STATE OF VERMONT AGENCY OF TRANSPORTATION

PROPOSED IMPROVEMENT CITY OF SOUTH BURLINGTON AND TOWN OF COLCHESTER COUNTY OF CHITTENDEN INTERSTATE 89 NB & SB

PROJECT DESCRIPTION: PREVENTIVE MAINTENANCE TO EXISTING CULVERTS INCLUDING THE INSTALLATION OF PIPE LINERS AND HEADWALLS ALONG WITH THE CONSTRUCTION OF NEW CULVERTS USING TRENCHLESS TECHNOLOGY ALONGSIDE THE EXISTING CULVERTS.

RECORD PLANS	
CONTRACTOR:	MORRILL CONSTRUCTION INC - NORTH HAVERHILL, NH
RESIDENT ENGINEER:	GREG WILCOX
CONSTRUCTION BEGAN:	JUNE 13, 2011
CONSTRUCTION COMPLETE:	AUGUST 29, 2012
RECORD PLANS BY:	GREG WILCOX & JENNA HYDE
I HEREBY CERTIFY THAT ALL THE CONSTRUCTION REQUIRED BY THIS SET OF DRAWINGS HAS BEEN ACCOMPLISHED AS INDICATED HEREIN.	
BY:	RESIDENT ENGINEER
DATE:	7/18/13
NOTE: Any further information concerning final quantities, amounts or other details relative to this project may be found at Central Files in the electronic archives.

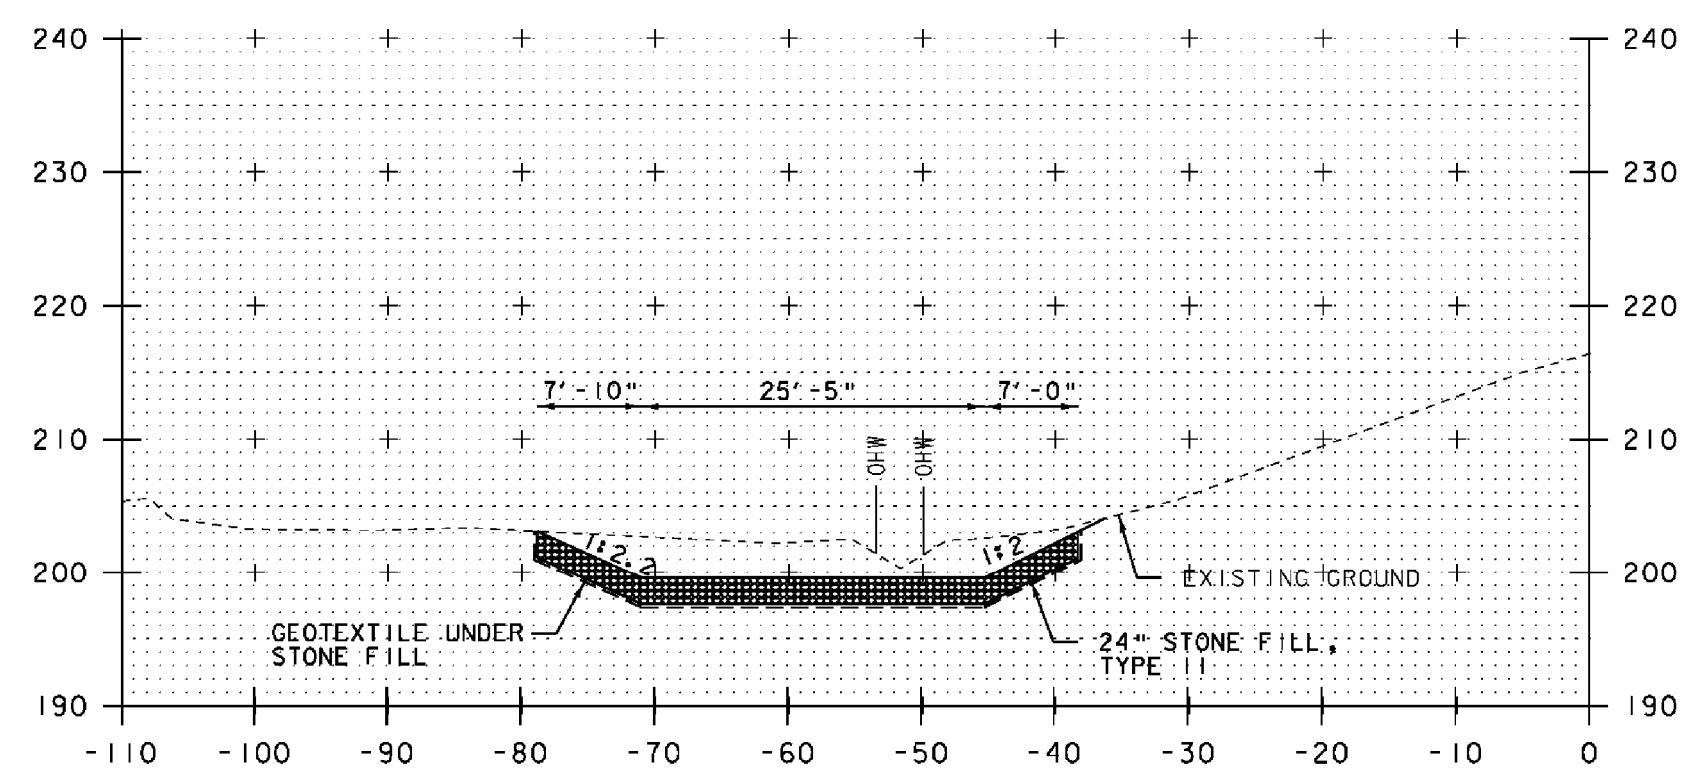
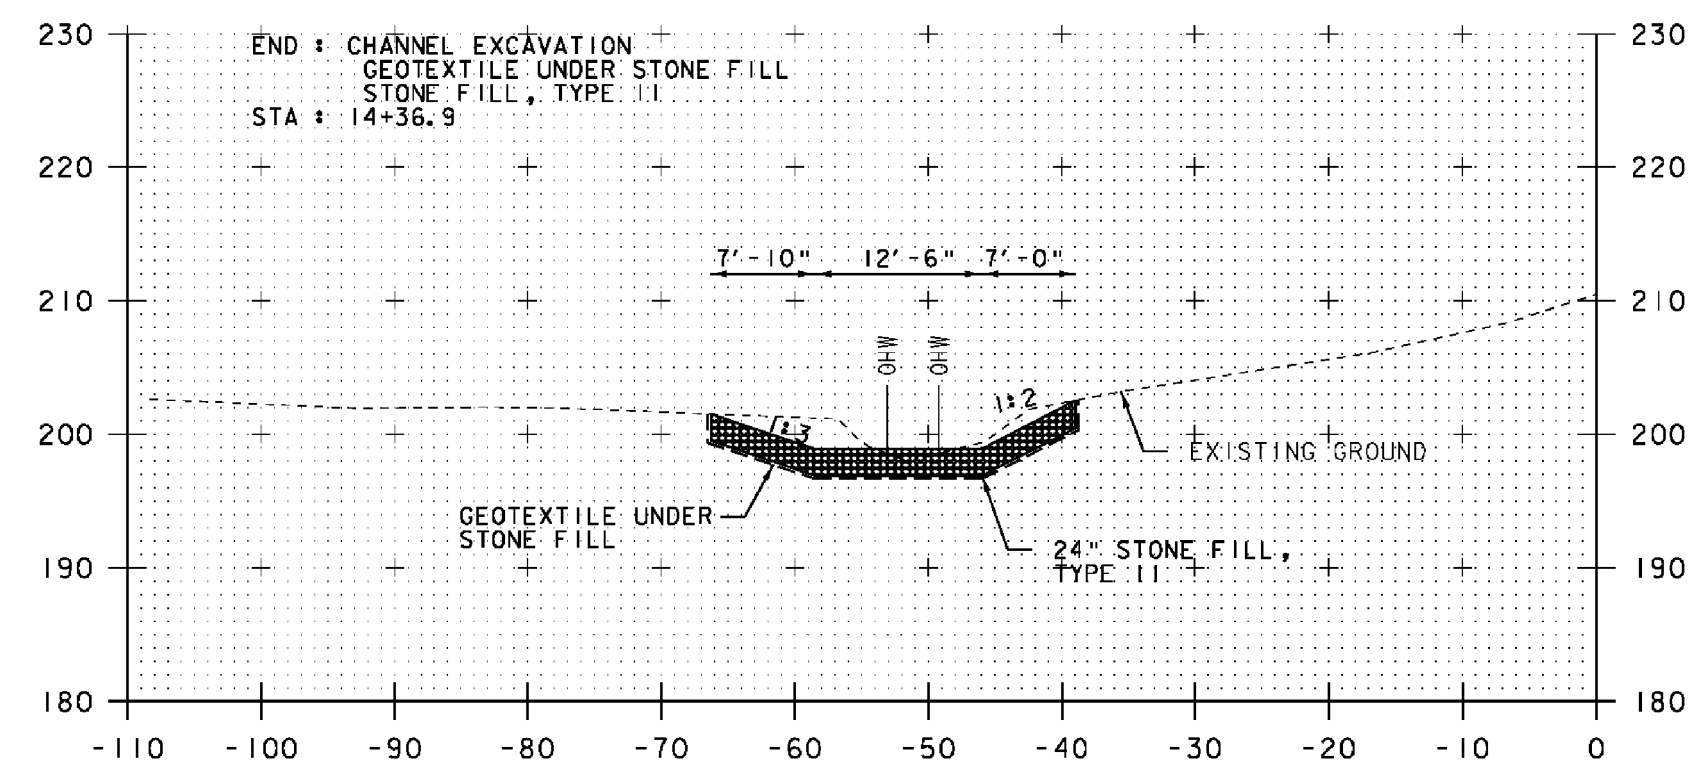
SEE C.O./S.A. #5 FOR CHANGE
TO FULL HEAWALL, NO BEVEL.

HEADWALL ELEVATION (INLET & OUTLET)

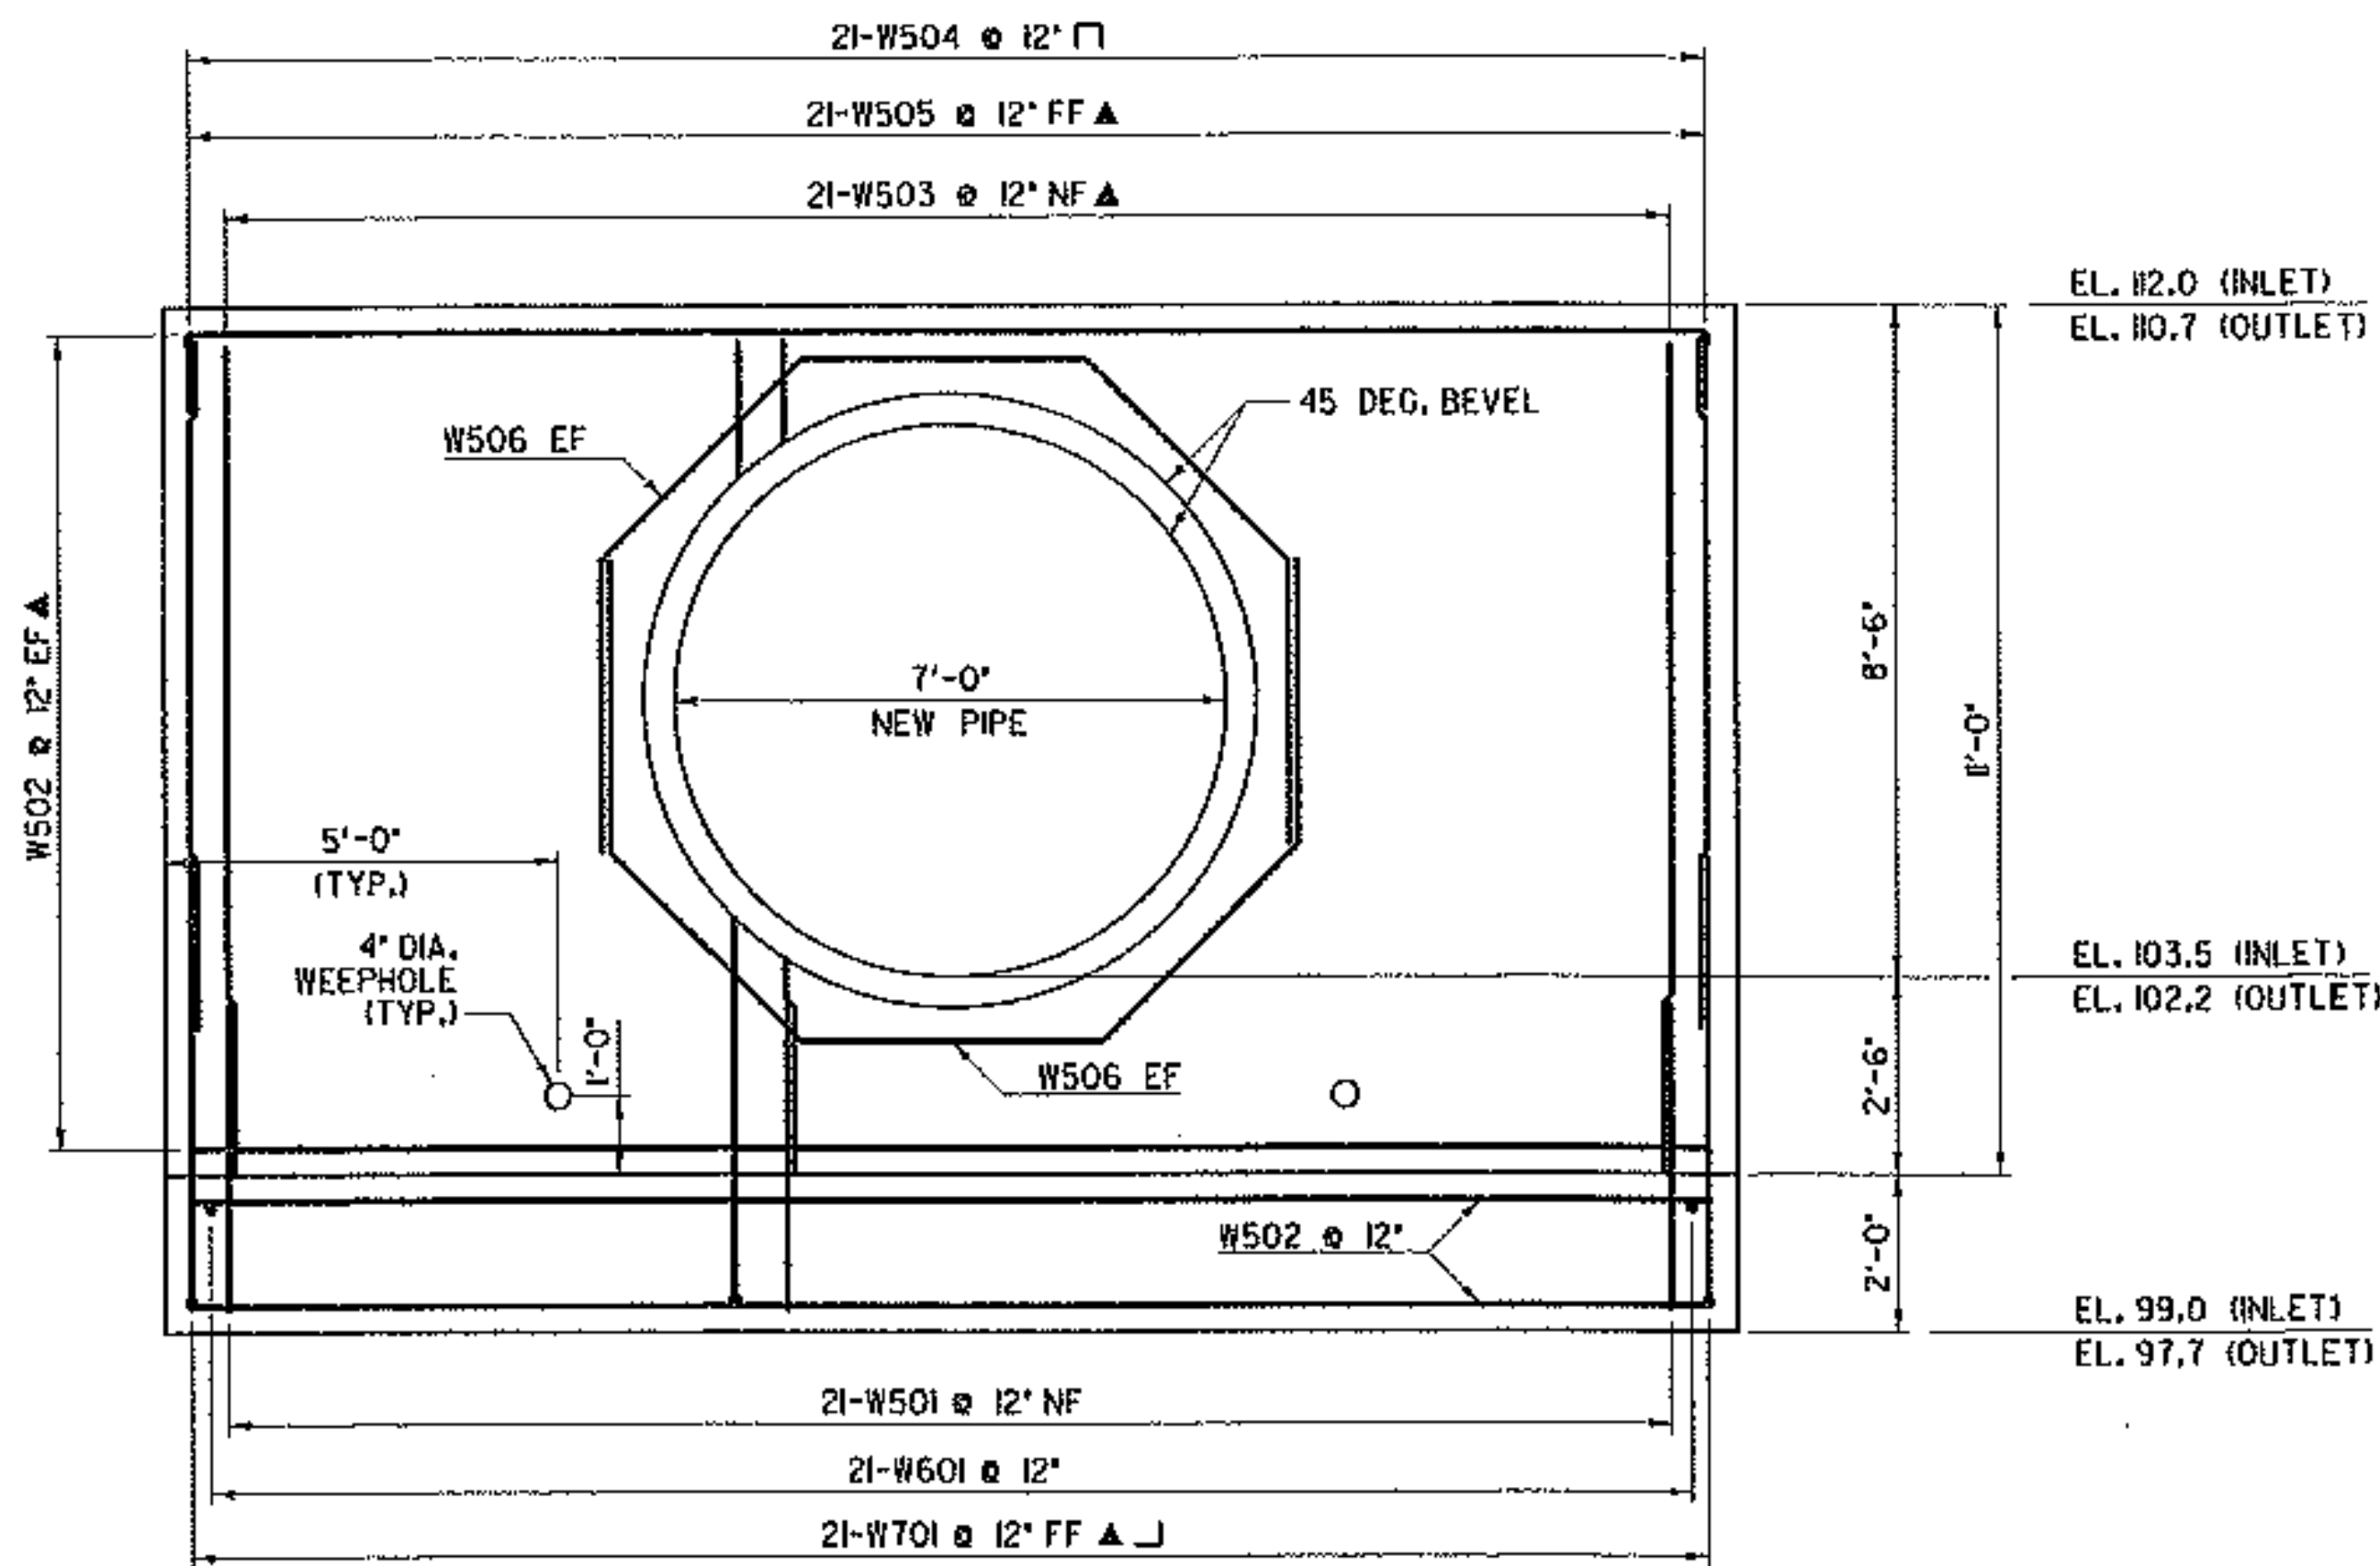
Handwritten notes: *Handwritten notes: Part of D.M.P. Sewer Pipe elevated*
